#### HISTORIC DOWNTOWN ADVISORY COMMISSION

Village Green Municipal Building, Council Chambers 47 Hall Street Thursday, November 19, 2015 6:00 P.M.

#### 1. CERTIFICATE OF APPROPRIATENESS

Applicant: Jim and Nita Biersdorf Location: 57 W. Olentangy Street

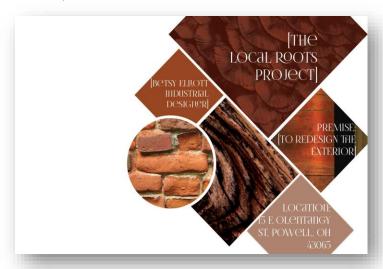
- Overall size should not exceed 18 square feet in the Historic District.
  - o The proposed sign is 48 square feet. Staff does not see the size of the sign having a negative impact on the front façade of the building or to the historic district. The intent of the size requirements is to ensure that signs are not out of scale. This sign is not out of scale, especially when the scale of the building is taken into account. Local Roots has a large entrance wall and a larger sign will not seem out of place. An example of a large sign on a large building face can be seen at with Kraft House #5 (see attached). In staff's opinion, larger signs that add to the aesthetic of downtown should be permitted.

- Wood is the preferred material for signs.
  - o The applicant is proposing a metal sign. Staff in this instance, sees the architectural and artistic value of the sign. However, staff defers to the Commission for their opinion.

- 1. The applicant has met the standards of the HDAC, Architectural Advisor, and Staff.
- 2. That the applicant has clarified staff's questions.
- 3. The HDAC approves the size variance to allow the larger 48 square foot sign.
- 4. The sign in the other gable to the west is removed.
